EXETER
COLLEGE
OXFORD

A New Quad at Walton Street
Planning Addendum Statement
October 2013

Changes to the Ruskin Building proposed at Planning submission. March 2013

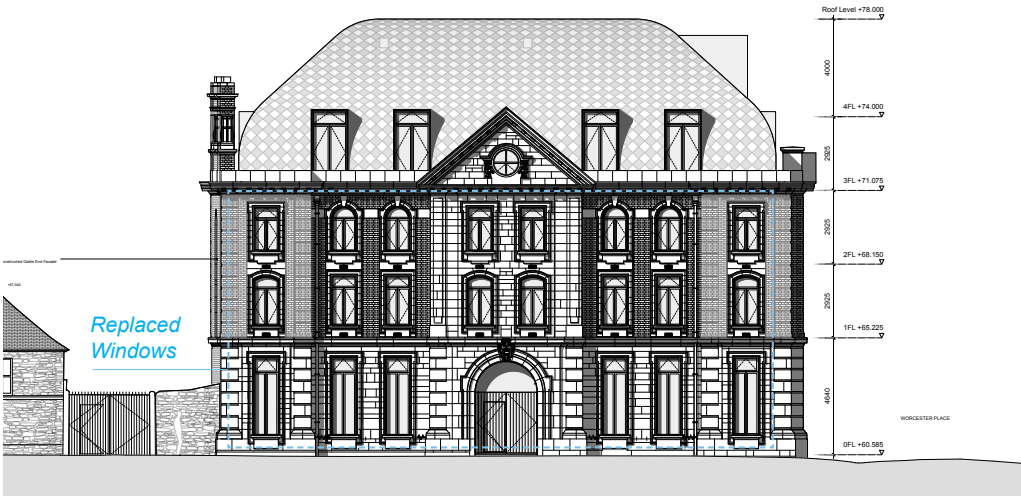
The Project Team originally proposed to replace the existing deteriorating sash windows with new casement windows to provide greater thermal and acoustic performance. The more open frame of casement windows with opening fanlight would provide better lighting and natural ventilation to the public spaces on the ground floor as well as the student rooms. Along with the new roof, the intention for the replacement was to add a new layer of meaning representing both Ruskin's heritage and Exeter College at the Walton Street site. However during the consultation process the significance of preserving the window detail of the Ruskin elevation was highlighted.

Ruskin Building retained facade and retained windows visualization

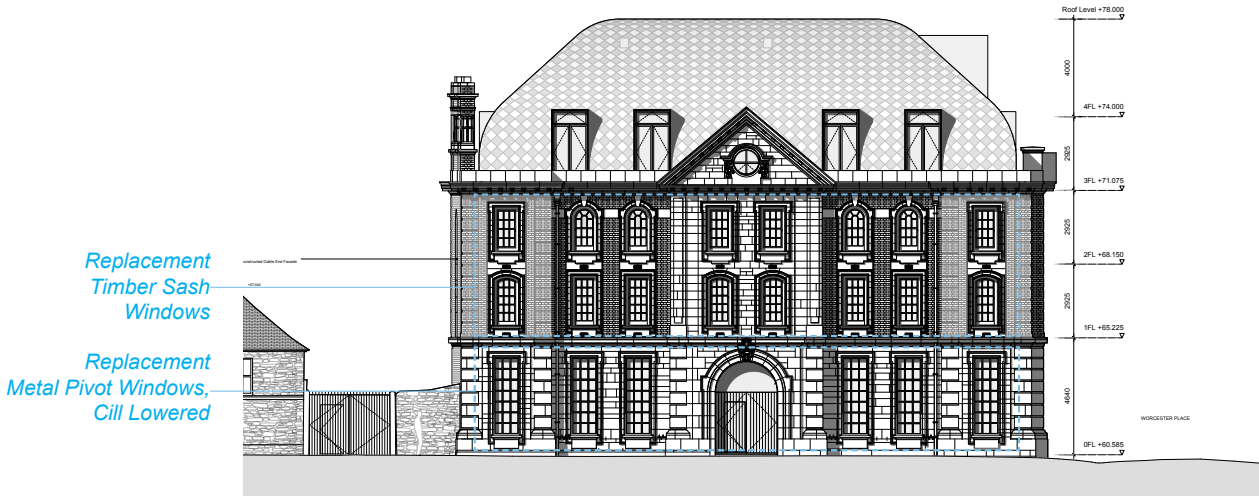
During the application process the team changed its approach of using casement windows as a universal replacement for all the Ruskin building windows. A like-for-like restoration and replacement approach has been adopted instead.

The ground floor windows will be replaced with new double-glazed thermally broken steel-framed windows with glazing bars to match the existing. The upper floor windows will be replaced with an exact double glazed timber sash replica or restored, subject to further investigation of the window frame conditions.

Walton Street Windows

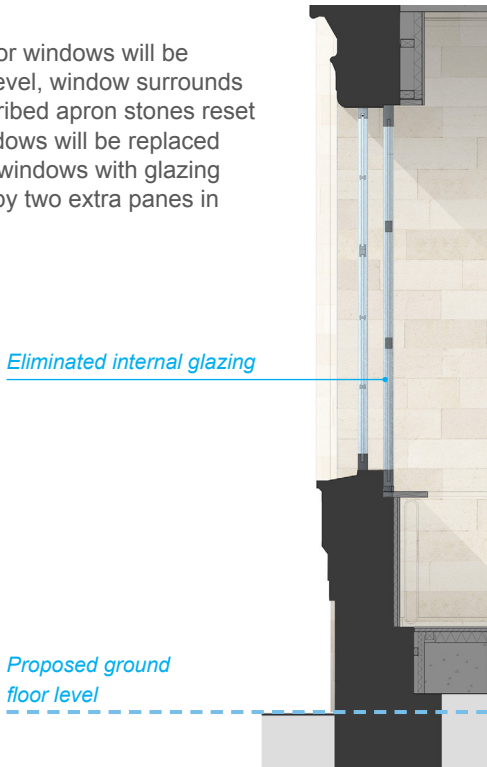
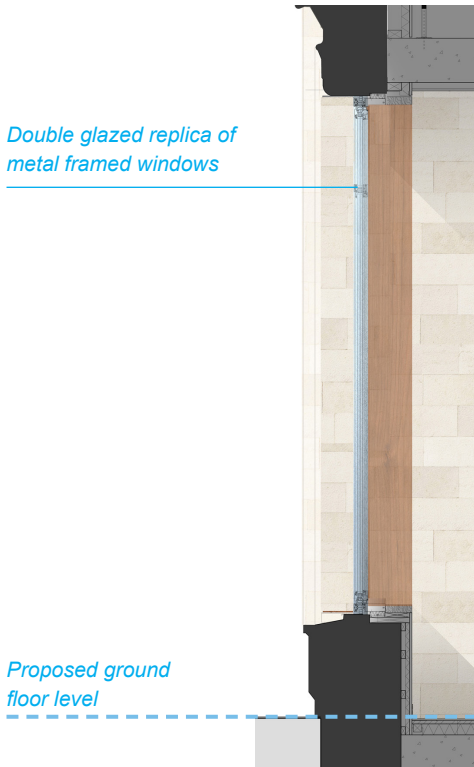
The sills and aprons of the ground floor windows will be lowered to suit the new ground floor level, window surrounds will be extended and the existing inscribed apron stones reset at a lower level. The ground floor windows will be replaced with new steel-framed double glazed windows with glazing bars to match the existing, extended by two extra panes in height.

Worcester Place Windows

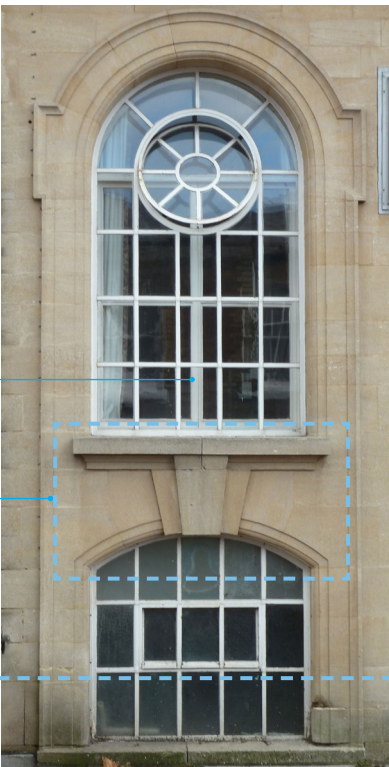
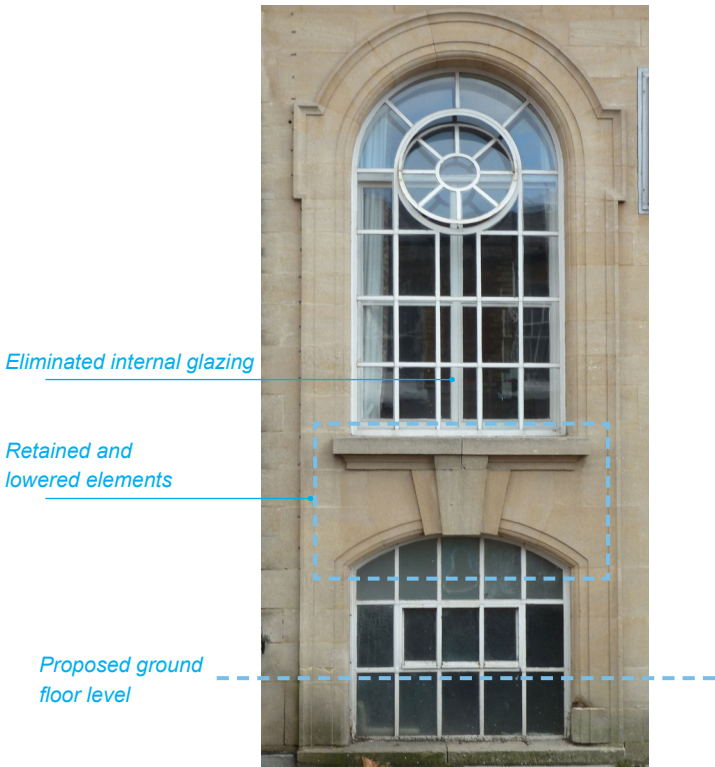
The sills, aprons, arches and keystones of the ground floor windows on Worcester Place will be lowered to suit the new ground floor level, window surrounds will be extended and the remainder of the second window into the basement filled in with matching stone. The window frames will be replaced with new steel-framed double glazed windows with glazing bars to match the existing, with two extra panes in the height. The existing secondary internal glazing, thought to have been added to mitigate external noise and heat loss, will be removed.

1 Existing Elevation Ruskin East Facade Ground Floor Window

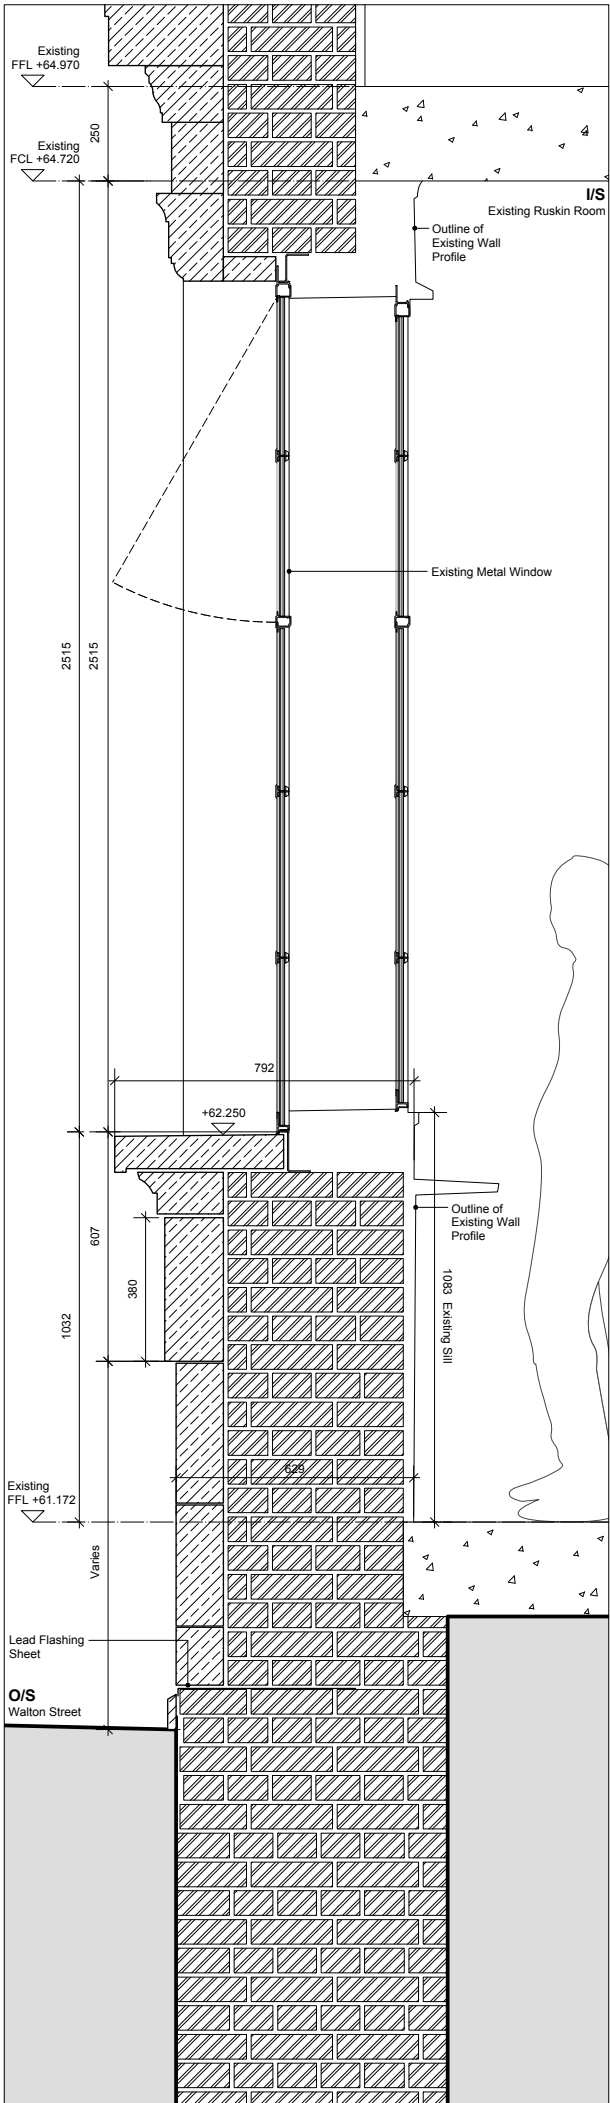
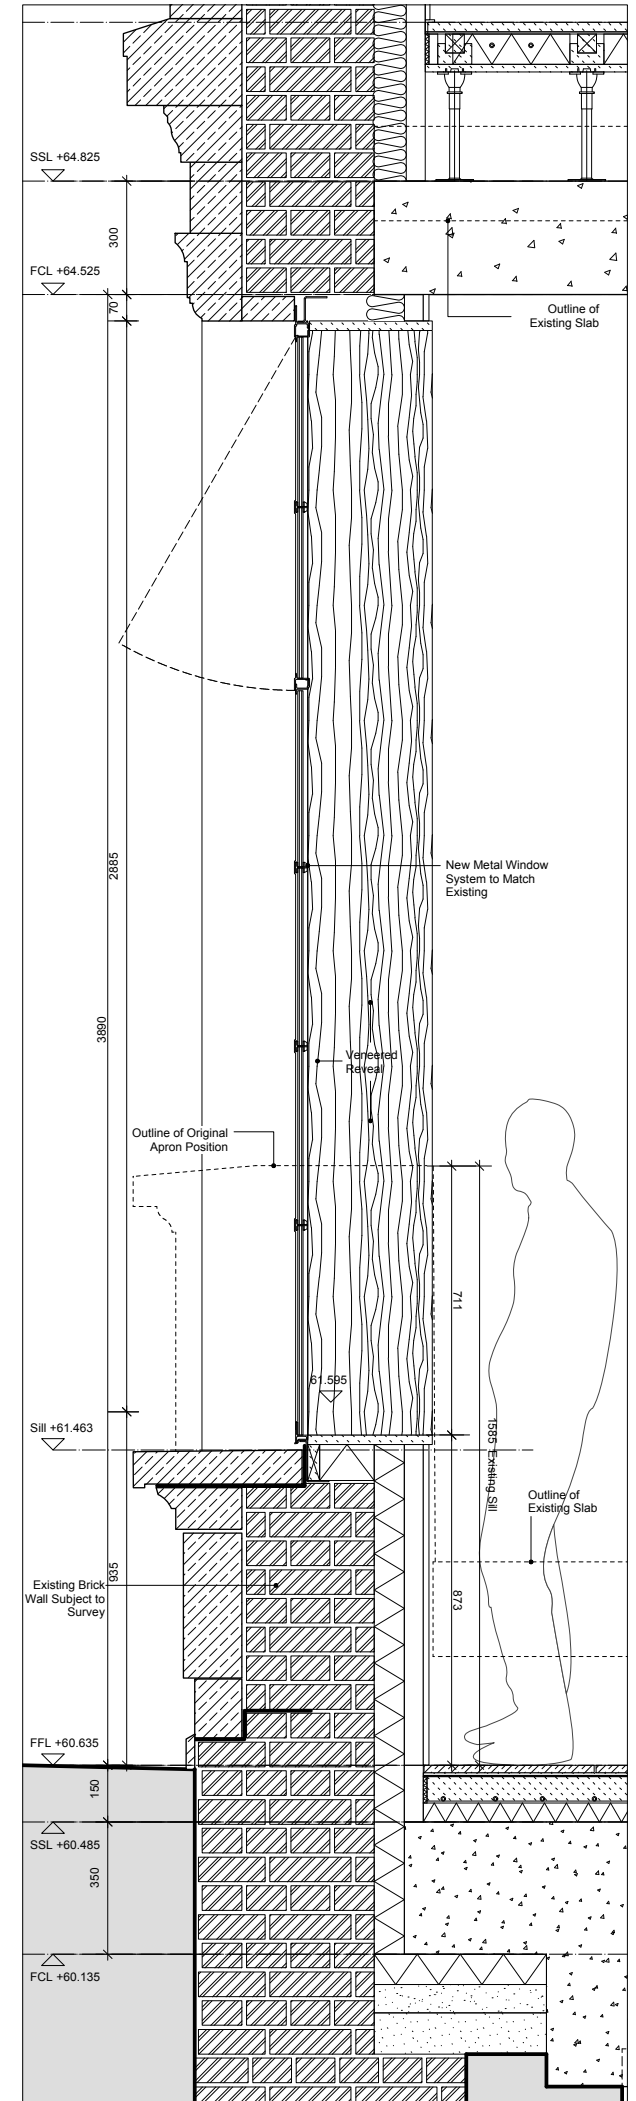
For the ground floor windows on Walton Street and first pair of windows on Worcester Place, the deep relief and shadowing of the raiussed base mold has been identified as an appropriate placement level defining the bottom ledge of the stone window cill. This strategy creates an internal cill height of 870mm within the restored Ruskin Room.

3 Proposed Elevation Ruskin East Facade Ground Floor Window

4 Proposed Section Ruskin East Facade Ground Floor Window

1 Existing Elevation Ruskin North Facade Ground Floor Window

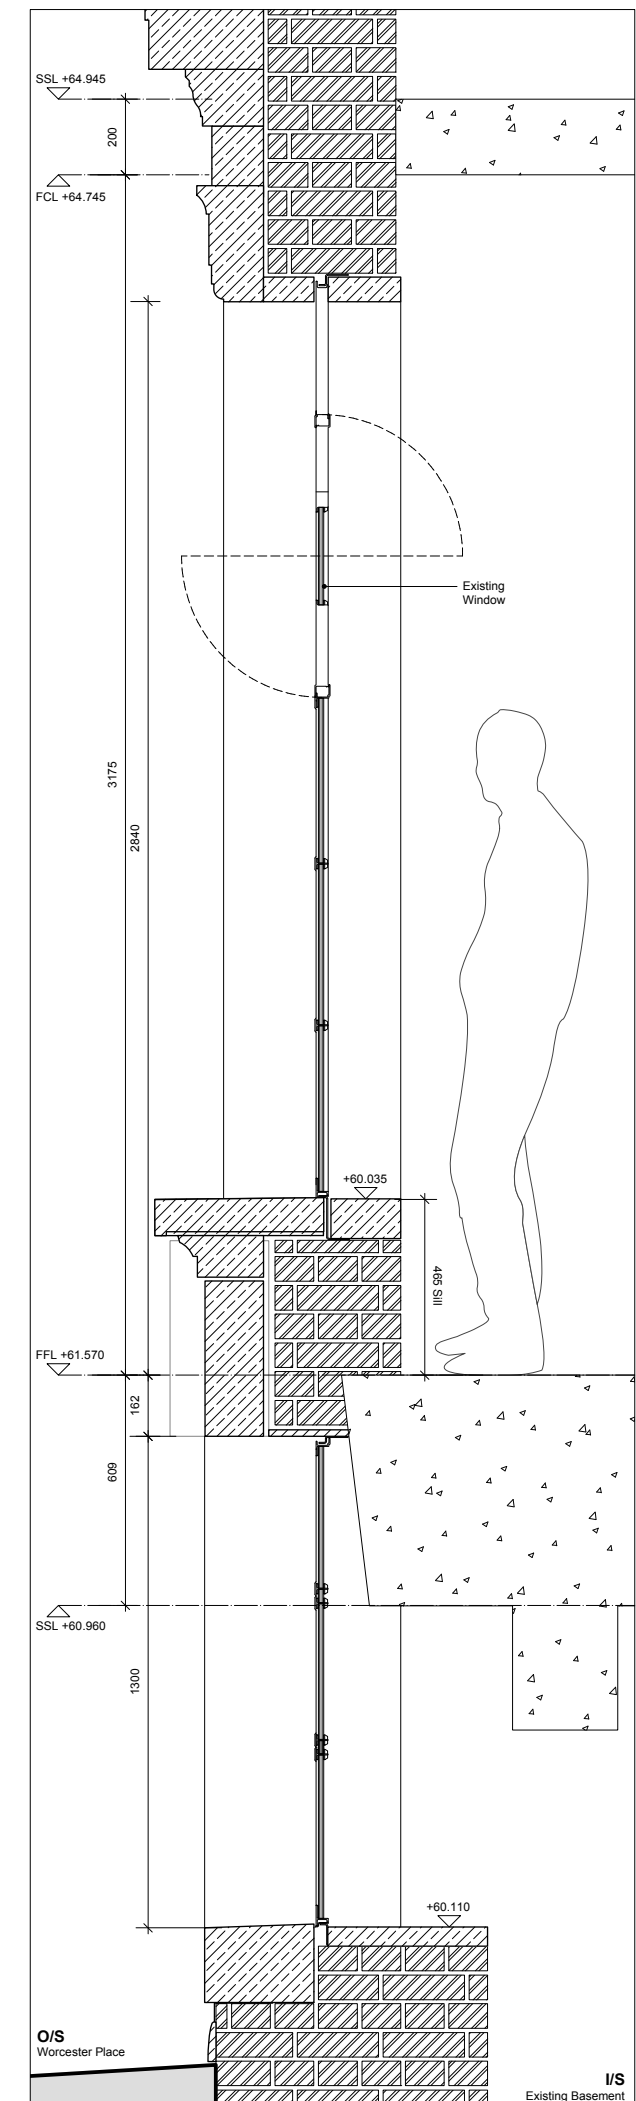
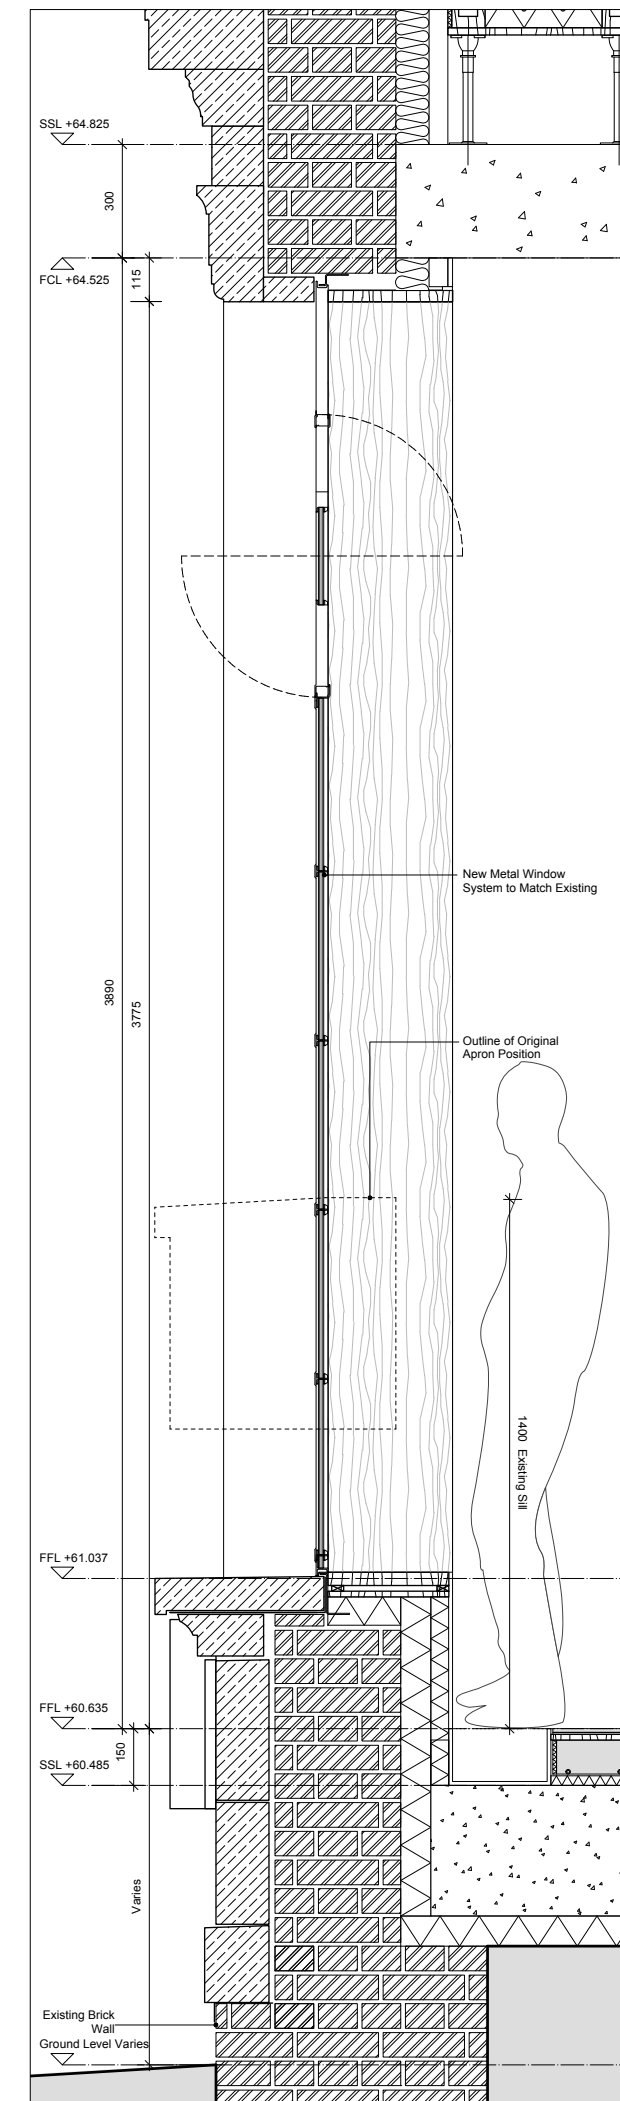
Alison Brooks Architects' original planning submission drawings illustrated a condition where these windows were lowered to reflect the internal finished floor level, in the manner of French doors with an opening fanlight.

Dialogue with English Heritage and OCC Conservation officers have since led to a conclusion that the lowered cill level of the four Worcester Place windows need not align with the Walton Street windows, and correspondingly do not necessarily need to reach the floor, but should be positioned according to the new composition of the lower arched aperture.

1 Proposed Elevation Ruskin North Facade Ground Floor Window

2 Proposed Section Ruskin North Facade Ground Floor Window
